SUBJECT: COMANCHE PEAK NUCLEAR POWER PLANT, UNITS 3 AND 4
DOCKET NUMBERS 52-034 AND 52-035
RESPONSE TO REQUEST FOR ADDITIONAL INFORMATION NO. 4760

RESPONSE TO REQUEST FOR ADDITIONAL INFORMATION

RAI NO.: 4760 (CP RAI #171)

SRP SECTION: 03.07.02 - Seismic System Analysis

Figure 1 – Comparison of Design Response Spectra to the UHSRS In-Structure Response Spectra at Basin Slab

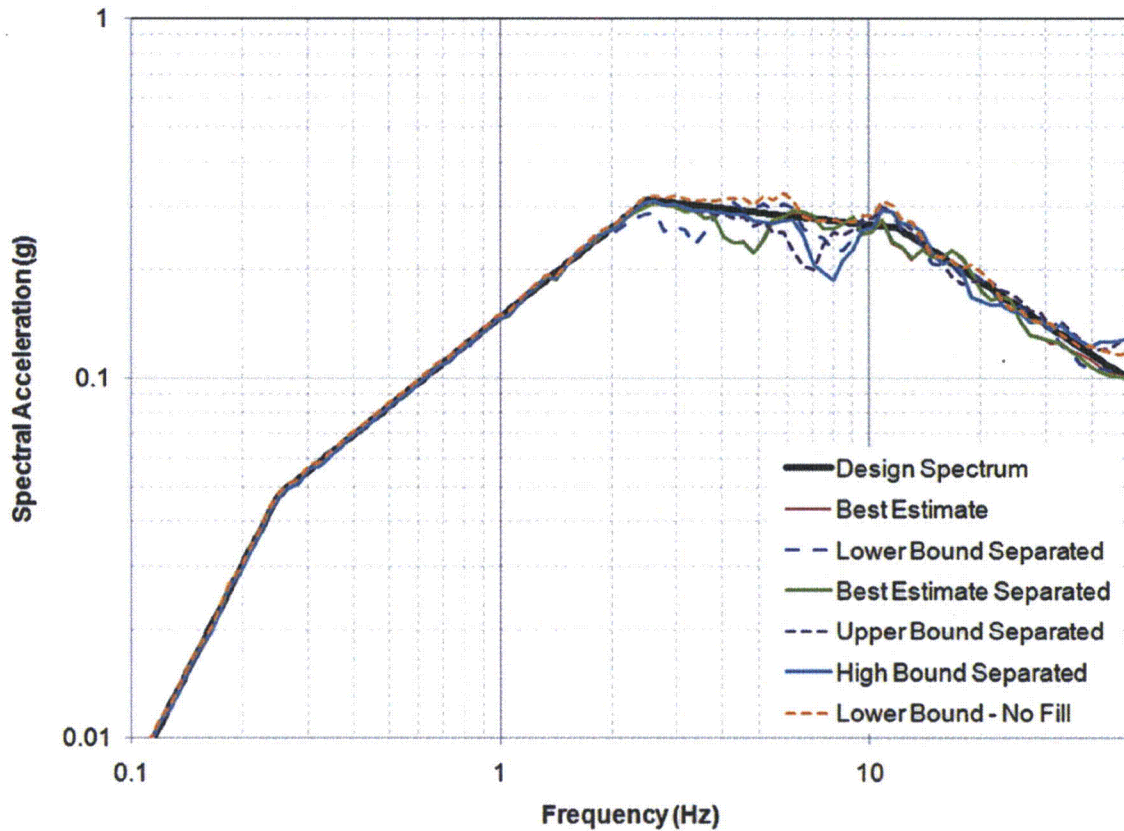
The applicant is requested to discuss the potential impact of the nearby slopes indicated in the site profiles on the computed SSI responses to ensure that the computed seismic responses will not be under-estimated at some frequencies of interest.

The results of the SSI analyses indicate that the SSI effects on the response of the UHSRS are not significant because the limestone layer upon which all UHSRS are founded is relatively stiff. Figure 1 below presents the in-structure response spectra (ISRS) obtained from the SSI analyses of the UHS basin foundation slab for the best estimate and lower bound no-fill cases and for the embedded cases (lower bound separated, best estimate separated, upper bound separated, and high bound separated), together with the horizontal input design response spectra. The ISRS are similar to the design input response spectra except that the results of the embedded foundation SSI analyses show reductions of the amplitudes at the backfill soil column frequencies where the backfill influences the rock in-layer response spectra, thus indicating that the SSI effects on the seismic response of the UHSRS are small. As a result, responses of the UHSRS are not considered to be sensitive to variations in the surface geometry or properties of the limestone due to the presence of the reservoir. Therefore, the presence of the reservoir slope does not impact the SSI results, and the use of a horizontally-infinite half-space and consideration of a broad range of embedment conditions ensures that the ISRS results envelope the actual site conditions.
